Reference: NRC letter to TVA dated January 13, 2006,
"Sequoyah Nuclear Plant, Unit 2 - Request for
Additional Information Regarding the 15-Day and
90-Day Steam Generator Tube Inservice Inspection
Reports for the End-of-Cycle 13 Refueling Outage
in 2005 (TAC No. MC8118)"

TENNESSEE VALLEY AUTHORITY (TVA)
SEQUOYAH NUCLEAR PLANT (SQN)
UNIT 2

RESPONSE TO REQUEST FOR ADDITIONAL INFORMATION REGARDING
STEAM GENERATOR REPORTS FROM CYCLE 13 REFUELING OUTAGE

Figure 1: Predicted EOC-14 Voltage Distribution, SG1

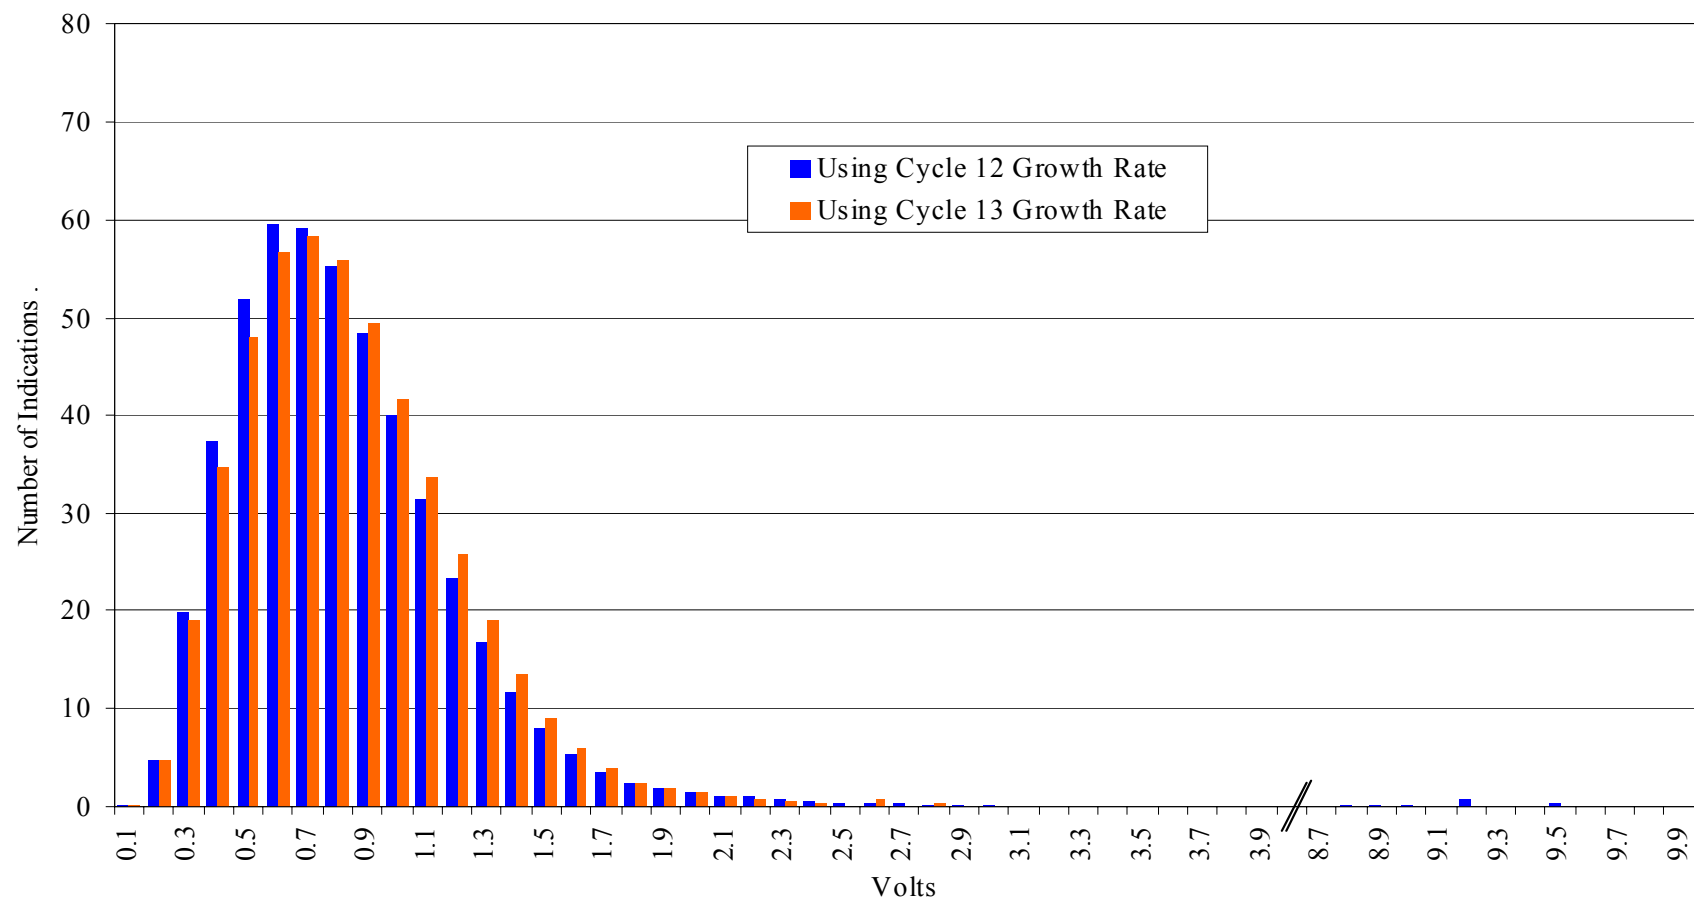
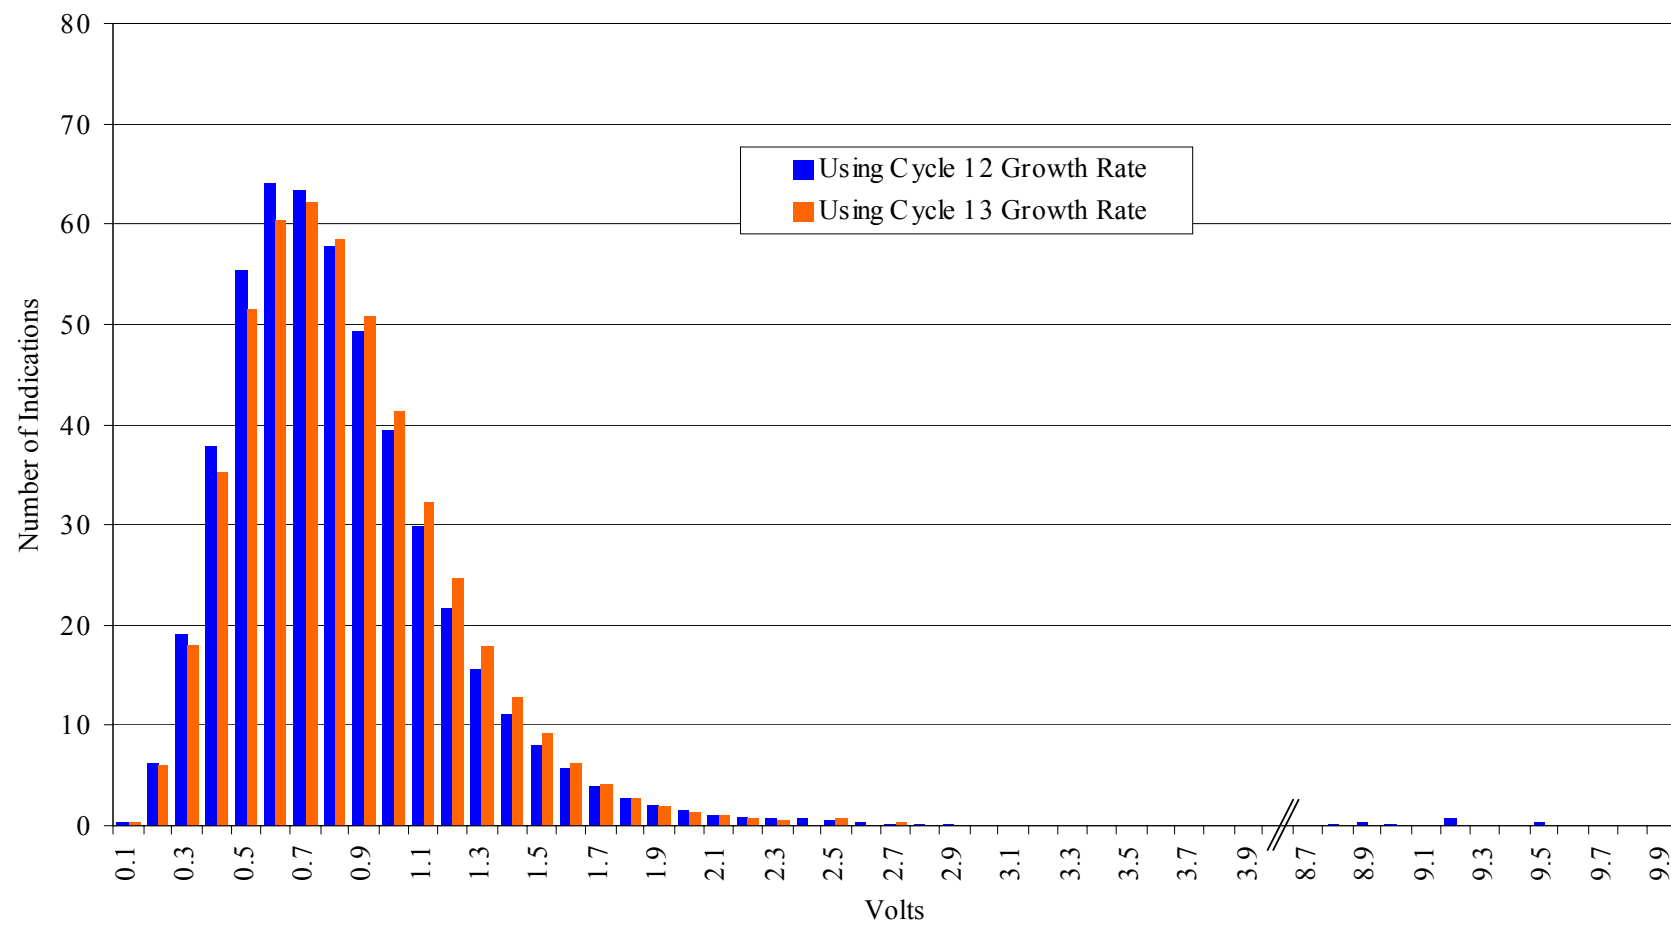
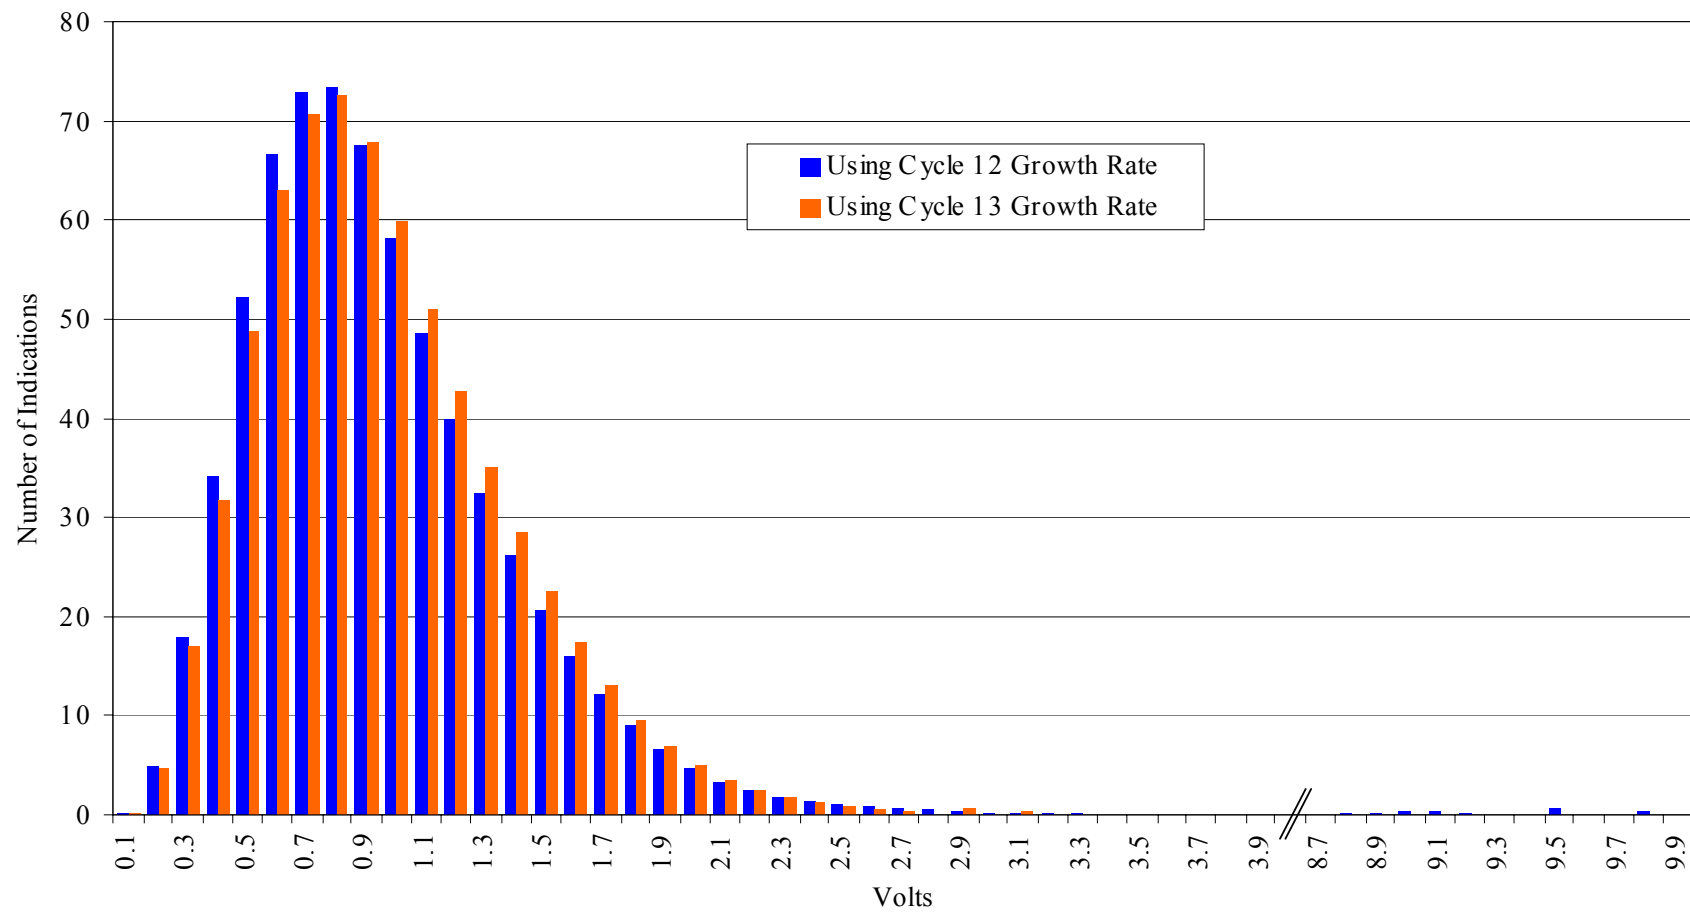
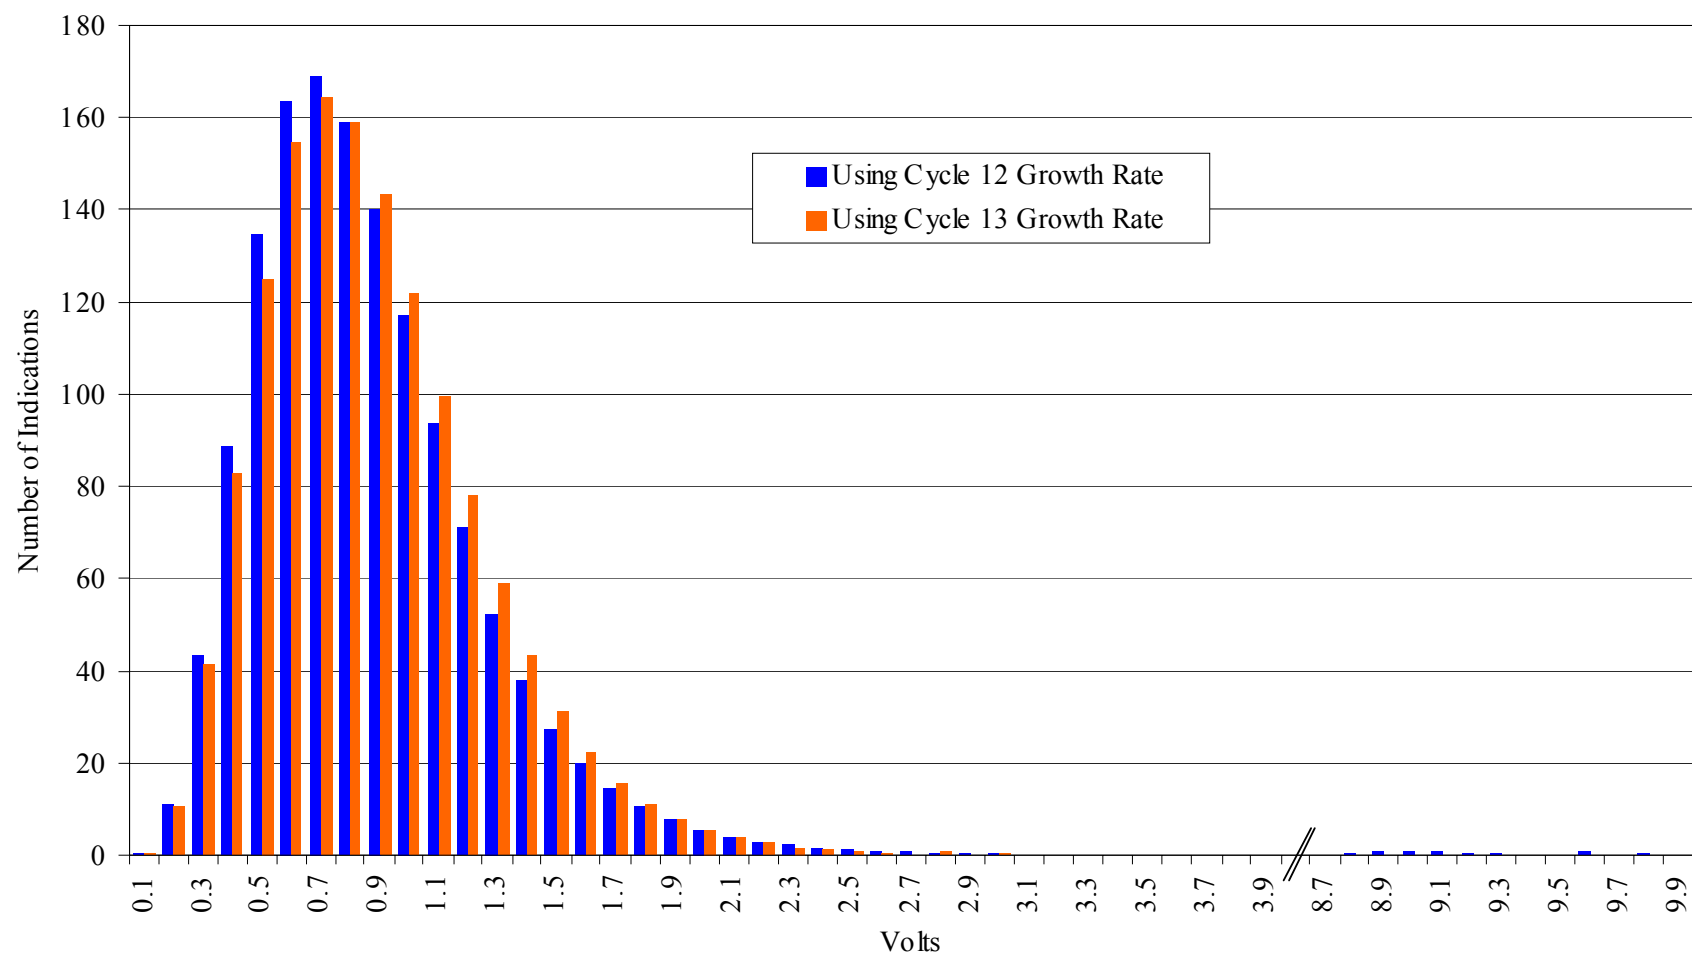
In Section 6.4 of Enclosure 1 to your August 15, 2005, letter, it was indicated that the EOC 14 voltage distribution (using both the Cycle 12 and Cycle 13 growth rates) are shown in Table 6-2 and in Figures 6-1 through Figure 6-4. In reviewing the table and figures only one voltage distribution was provided for each steam generator.

Please clarify whether the tables and graphs provided were determined using the Cycle 12 or Cycle 13 voltage growth rate distribution.

In addition, Section 6.4 indicates that the voltage distributions predicted using both growth rates are similar, however, the predictions using the Cycle 13 growth rates were populated with somewhat greater frequency in the lower voltages and with higher tail-end voltages. Since the most limiting voltage growth rate distribution is the one that results in the highest projected probability of burst and leakage, discuss how it was determined that the Cycle 12 growth rate distribution was the most limiting. The staff notes that sometimes the higher tail end voltages can result in more limiting probability of burst or leakage estimates (i.e., the largest voltage indication may have a significant effect on the leakage and burst calculations depending on the distribution of indications).

The Cycle 12 growth rate clearly has a longer upper tail due to the inclusion of the one large voltage indication found at EOC-12. Only the results using the Cycle 12 growth rate were included in the EOC-13 90 Day Report (Westinghouse Report SG-SGDA-05-29, Rev.0) since this did produce the more conservative results. The Table 6-2 and Figures 6-1 to 6-4 and Table 6-3 all are results using the Cycle 12 growth rate.

The reference to using both growth rates is an editorial error. The statement "voltage distributions predicted using both growth rates are similar, however, the predictions using the Cycle 13 growth rates were populated with somewhat greater frequency in the lower voltages and with higher tail-end voltages" is also an editorial error.

In order to demonstrate that the Cycle 12 growth rate results in the more conservative predictions the predictive results of using both the Cycle 12 and Cycle 13 growth rates are presented here. The analyses clearly indicate that the Cycle 12 growth rate results are more conservative. Therefore, the results in the report are correct.
